Uniform provisions concerning the approval of motor vehicles with regard to the Advanced Emergency Braking System (AEBS) for M₂, M₃, N₂ and N₃ vehicles

The intention of this Regulation is to establish uniform provisions for advanced emergency braking systems (AEBS) fitted to motor vehicles of the categories M2, M3, N2 and N3 primarily used under highway conditions.

Figure 1:
Left turn or right turn at the intersection

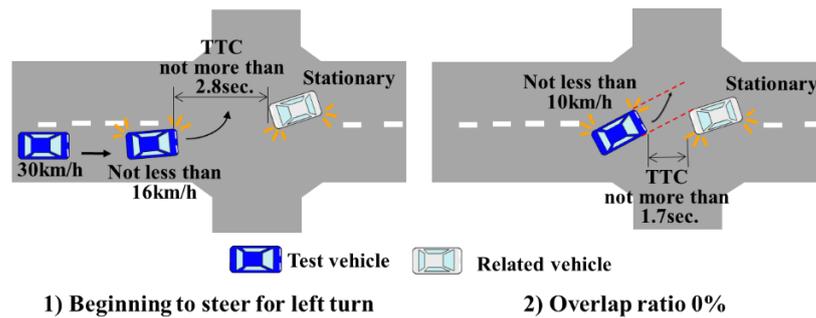
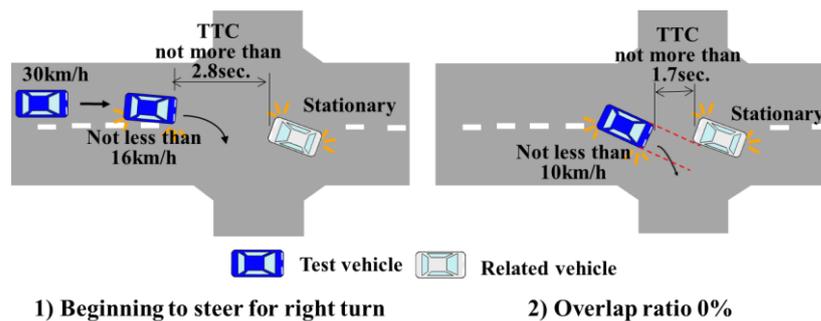
The blue car needs to be changed from passenger vehicle to large vehicle.

Figure 2:
Right turn or left turn of a forward vehicle

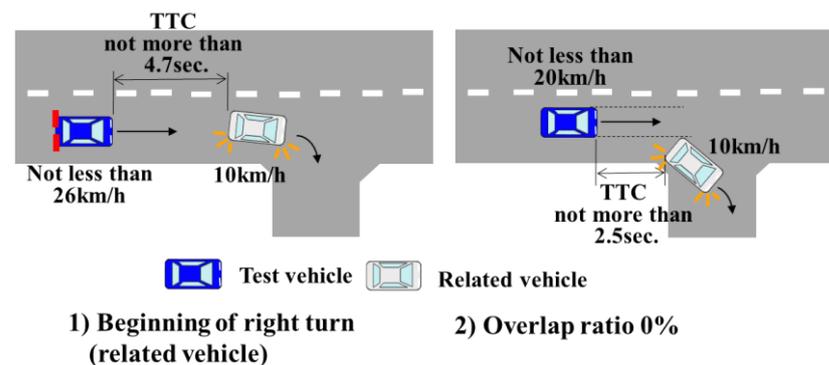
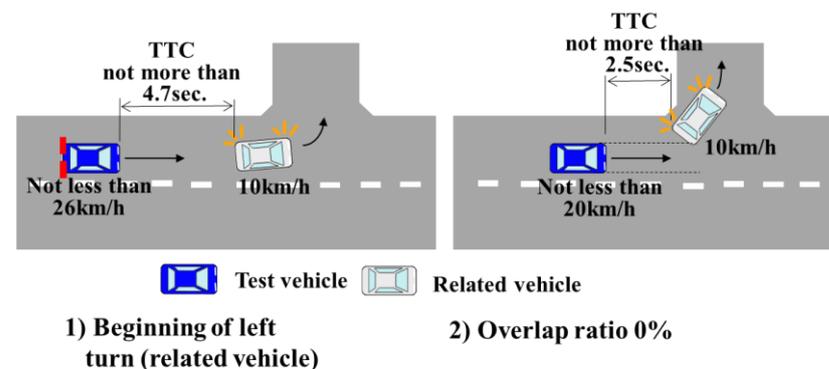
The blue car needs to be changed from passenger vehicle to large vehicle.

Figure 4:
Lane change due to road construction

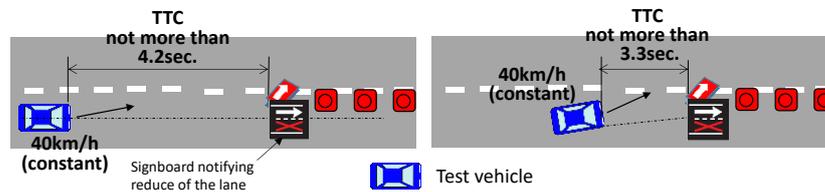
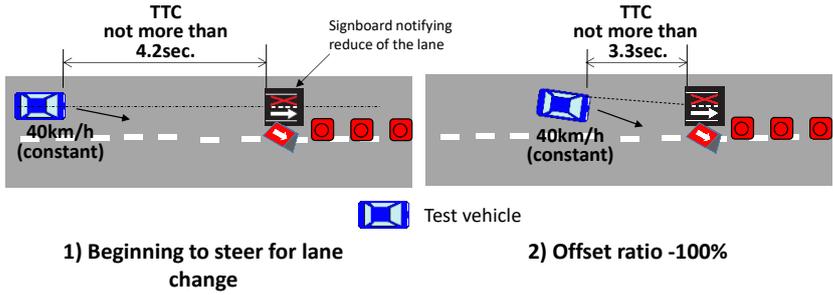
The blue car needs to be changed from passenger vehicle to large vehicle.
